THE PROVISION OF THE PORT ROAD UPGRADE AND REHABILITATION PHASE 1: UPGRADE AND REHABILITATION OF URANIA, NEWARK, AND VENTURA CONCRETE ROADS WITHIN THE PORT OF RICHARDS BAY FOR A PERIOD OF 18 MONTHS

CONTRACT NUMBER: TNPA/2025/06/0004/99874/RFP

Register #5

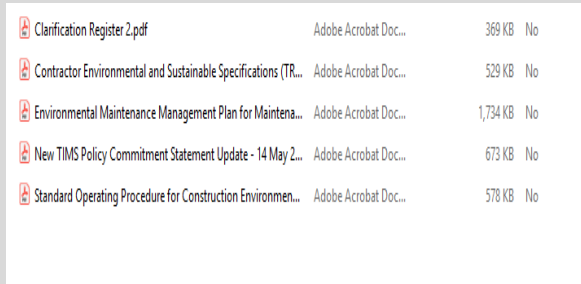
10	Commercial	16/09/2025	Kindly advise if the presentation shared during the tender briefing can be made available.	The presentation was uploaded on the portal, 10 September 2025.
11	BoQ	17/09/2025	Please could you clarify the following: On Addendum 1 amendments was made to items 71.06 of SCHEDULE B : NEWARK ROAD, SCHEDULE C : VENTURA ROAD and SCHEDULE D : URANIA ROAD SECTION 7100: CONCRETE PAVEMENTS below, is this a now a pay item as previously in the BOQ it was a heading, and it now had a unit and quantity against it?	Please note the quantity of dowels as shown in the table below are the total for all 3 roads (Schedules B, C and D). It is an amendment to the description only.

No.	Reference	Date Received	Clarification Required	TNPA Response																								
			Do we remove the installed in new concrete item or does it remain? The amended attached pages do not reflect the quantity 4600. Please advise if this is just an amendment to the description. <table><tr><th>ITEM NO</th><th>DESCRIPTION</th><th>UNIT</th><th>QUANTITY</th><th>RATE</th><th>AMOUNT</th></tr><tr><td></td><td>(d) Diamond dowels with pocket formers (stainless steel), 20 mm x 114 mm x 114 mm:</td><td>m</td><td>4600</td><td></td><td></td></tr></table> <table><tr><td>(d) Diamond dowels with pocket formers (mild steel stainless steel), 20 mm x 114 mm x 114 mm:</td><td></td><td></td><td></td><td></td><td></td></tr><tr><td>(i) Installed in new concrete</td><td></td><td>number</td><td>3 350</td><td></td><td></td></tr></table>	ITEM NO	DESCRIPTION	UNIT	QUANTITY	RATE	AMOUNT		(d) Diamond dowels with pocket formers (stainless steel), 20 mm x 114 mm x 114 mm:	m	4600			(d) Diamond dowels with pocket formers (mild steel stainless steel), 20 mm x 114 mm x 114 mm:						(i) Installed in new concrete		number	3 350

ITEM NO	DESCRIPTION	UNIT	QUANTITY	RATE	AMOUNT																							
	(d) Diamond dowels with pocket formers (stainless steel), 20 mm x 114 mm x 114 mm:	m	4600

(d) Diamond dowels with pocket formers (mild steel stainless steel), 20 mm x 114 mm x 114 mm:																												
(i) Installed in new concrete		number	3 350																									
12	Technical	17/09/2025	Please confirm if the below item thickness is correct as our supplier states that this could cause structural complications.	Please use the thickness as specified.
